**NUMBER:** 08-089-17

Horn Replacement

2017 (WK) Jeep Grand Cherokee

**Fig. 1**  
**Horn Electrical Connector**

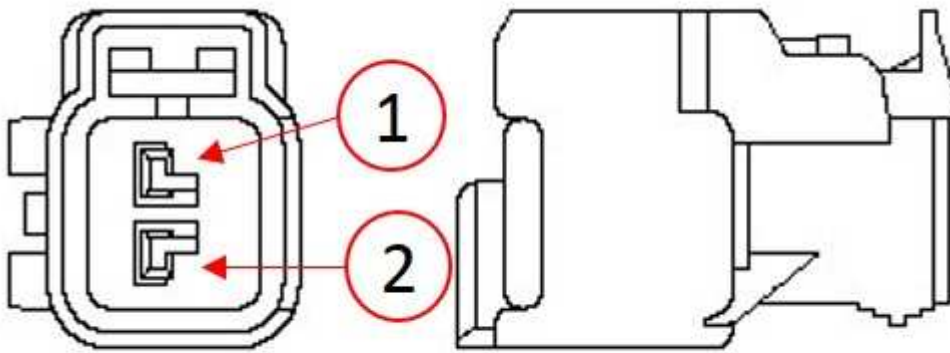
2. Cut the old electrical wiring harness connectors from both horns and dispose.
3. Use connector kit #68018954AA and replace both horn electrical connectors (Fig. 1) . Insert Dark Blue wire into Cavity 1 and then splice into Black Ground vehicle harness wire. Refer to the detailed service procedures available in DealerCONNECT> TechCONNECT under: Service Info>29 - Non-DTC Diagnostics/Circuit Testing Procedures/Standard Procedure>Wire Splicing.

4. Insert Dark Blue wire into Cavity 2 and then splice into Grey with Yellow tracer vehicle harness wire. Refer to the detailed service procedures available in DealerCONNECT> TechCONNECT under: Service Info>29 - Non-DTC Diagnostics/Circuit Testing Procedures/Standard Procedure>Wire Splicing.

1 - Ground Cavity  
2 - 12V Cavity
